B R O W N S V I L L E
PUBLIC UTILITIES BOARD

Date: November 16, 2023
To: All Vendors
Subject: Addendum #3

REFERENCE: B012-24 Town Resaca Watershed Project

ADDENDUM No. 3

Project No.:	42947.001
Issued:	6/26/2023
Drawn By:	MH
Checked By:	JWC
Scale:	AS NOTED
Sheet Title	RESACA BLVD (SITE 7 P&P)
Sheet Number	C507

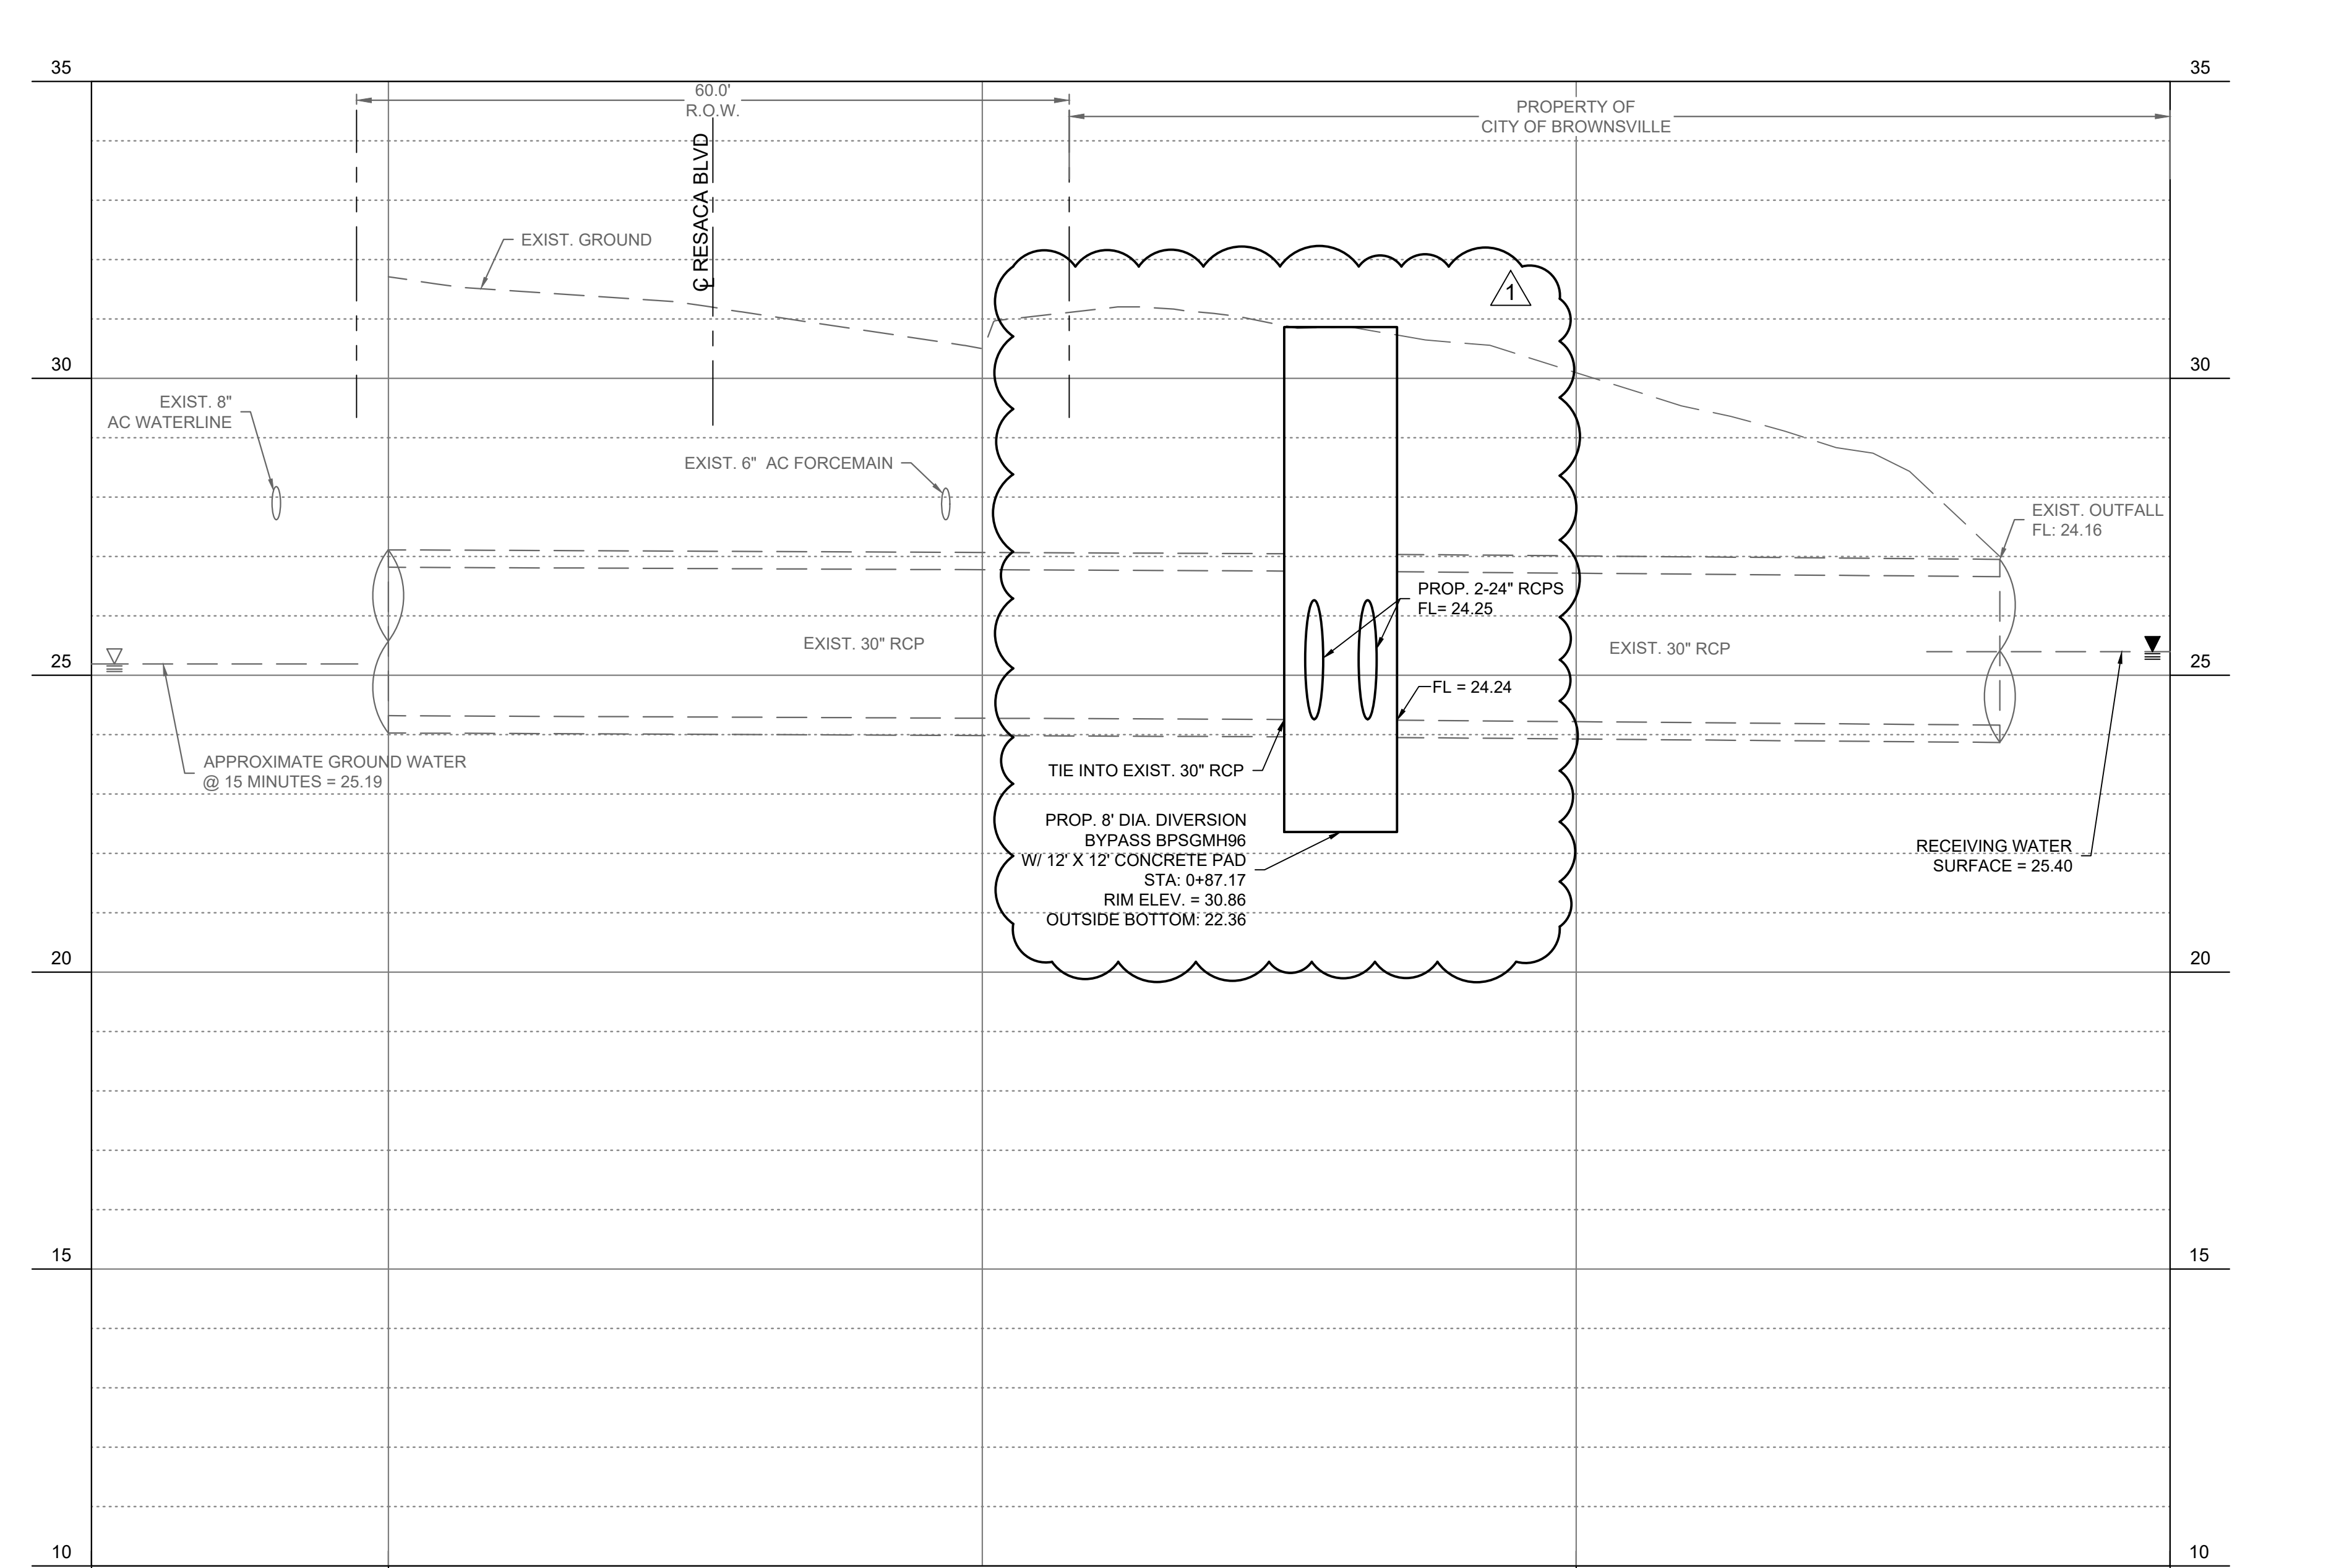
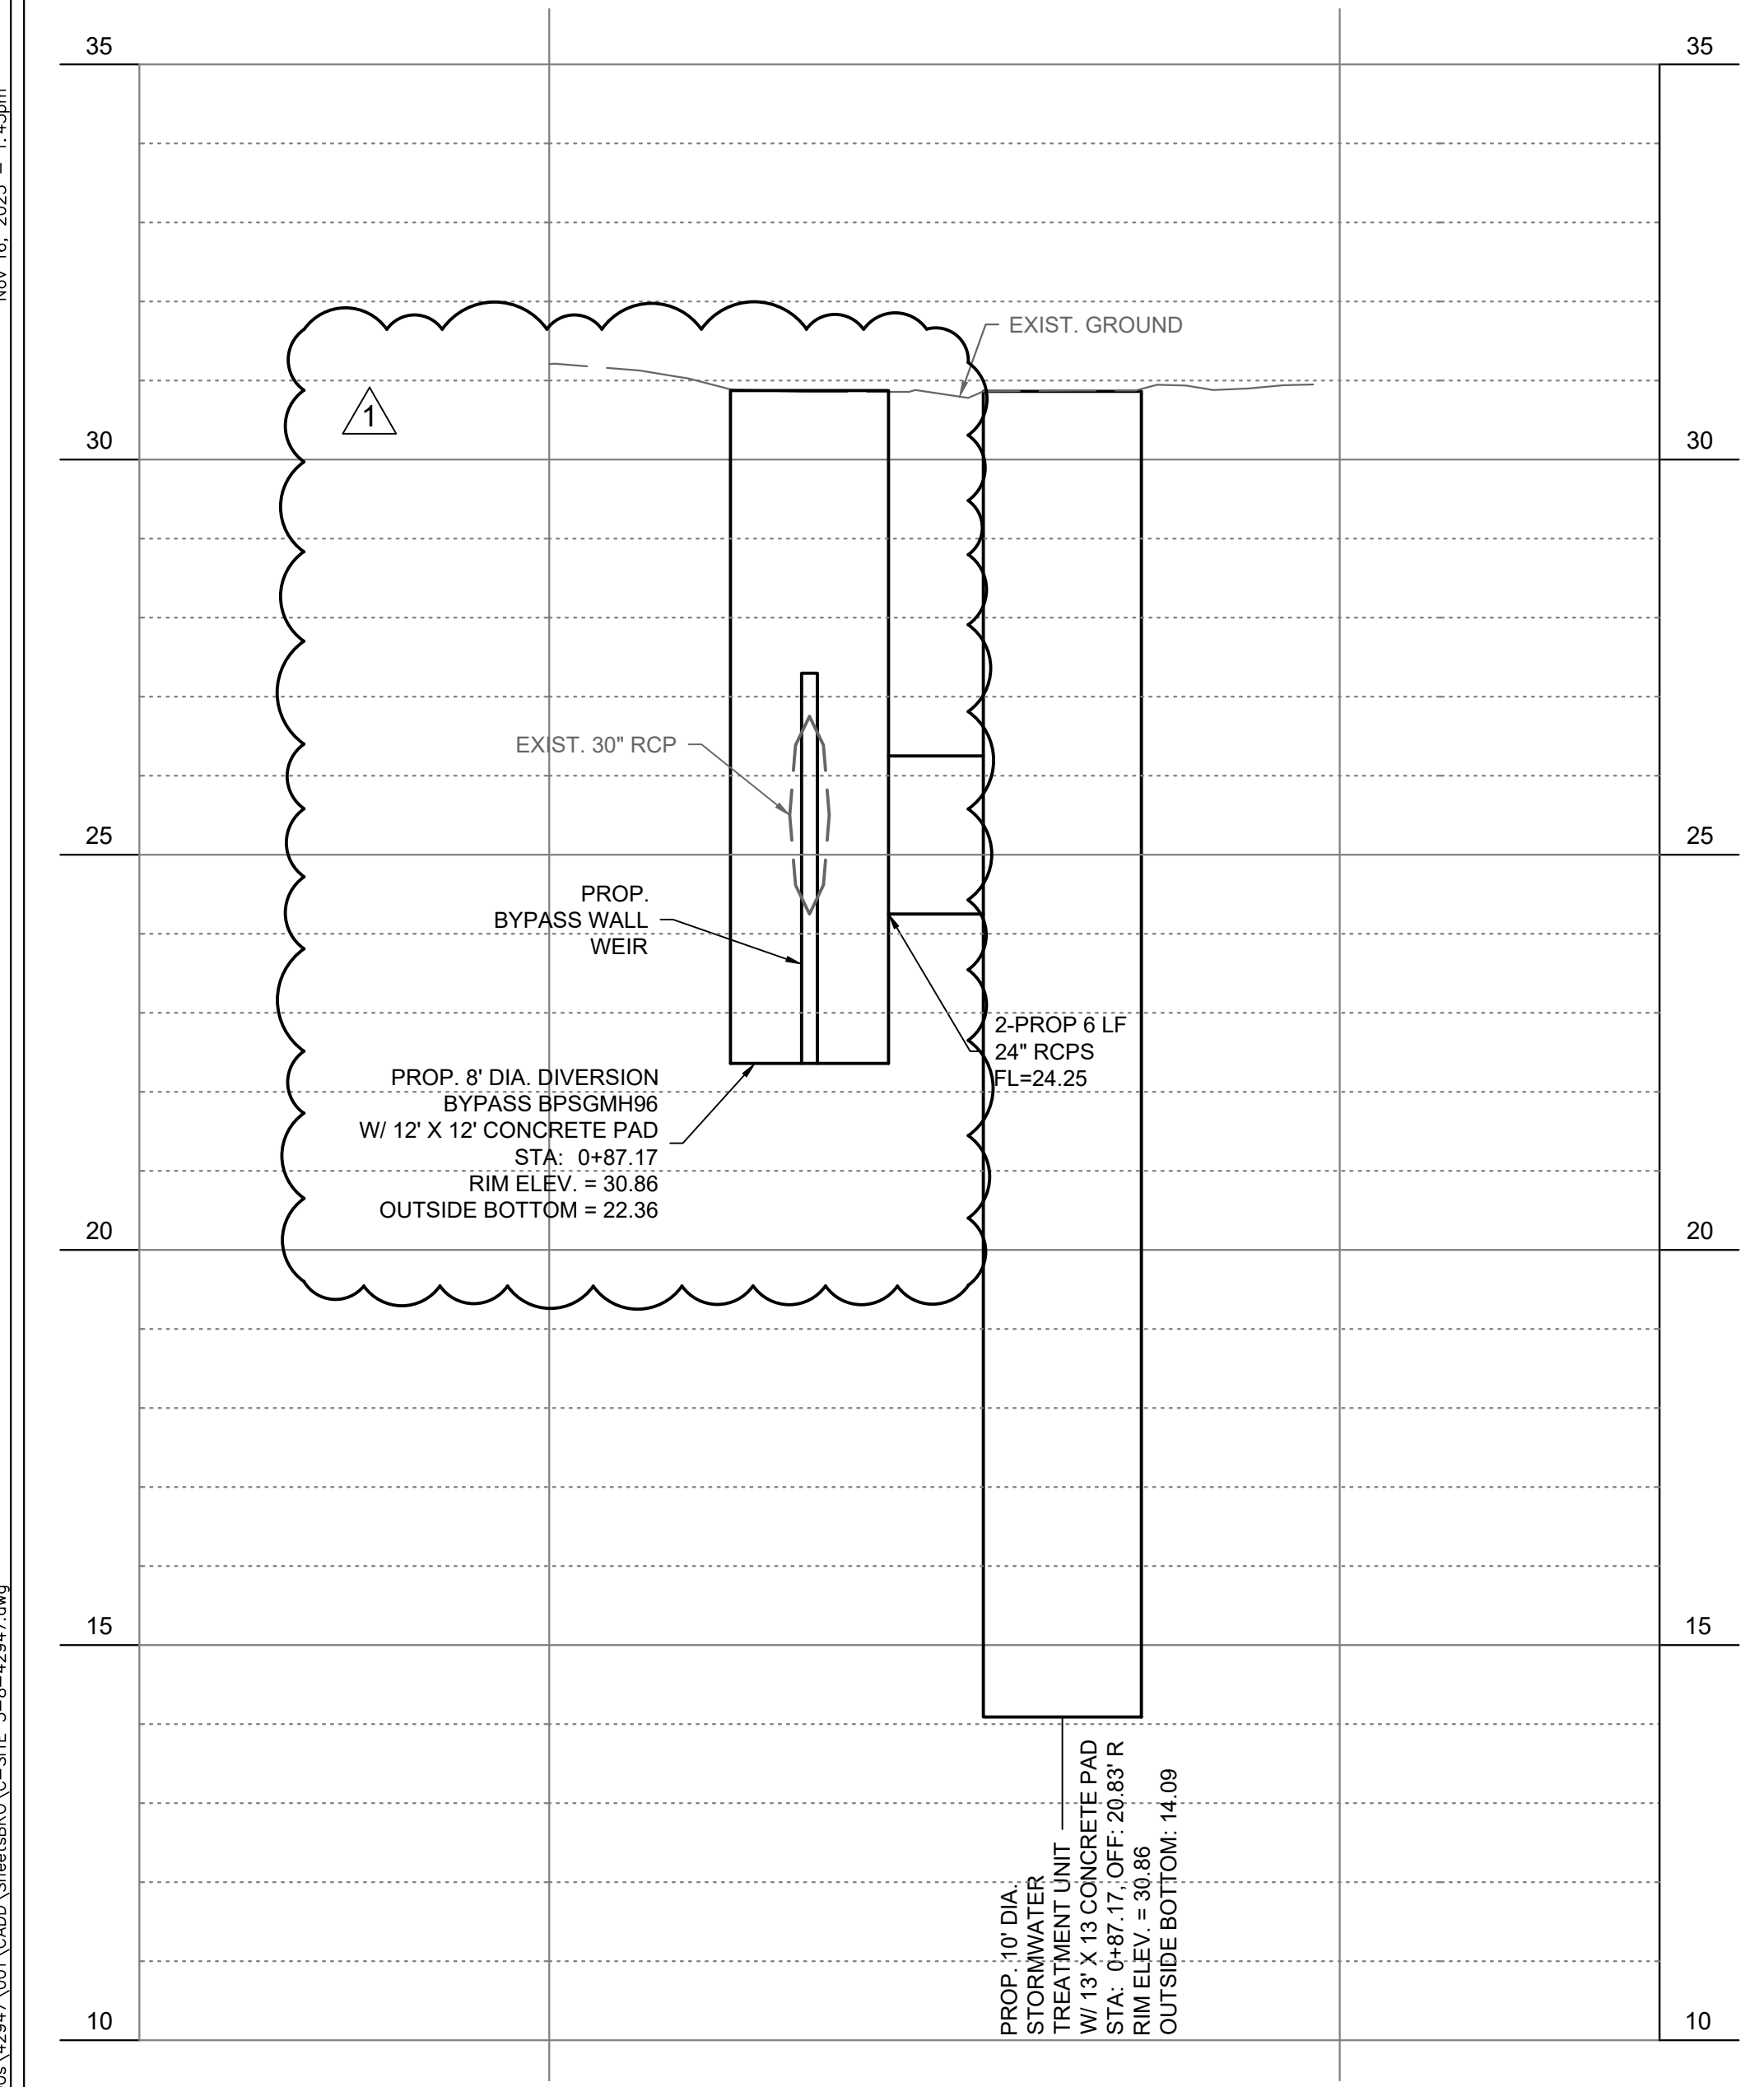
1. Revised Diversion Bypass BPSGMH96 outside bottom in sheet C507.
2. Revised Diversion Bypass BPSGMH96 detail in sheet C902.
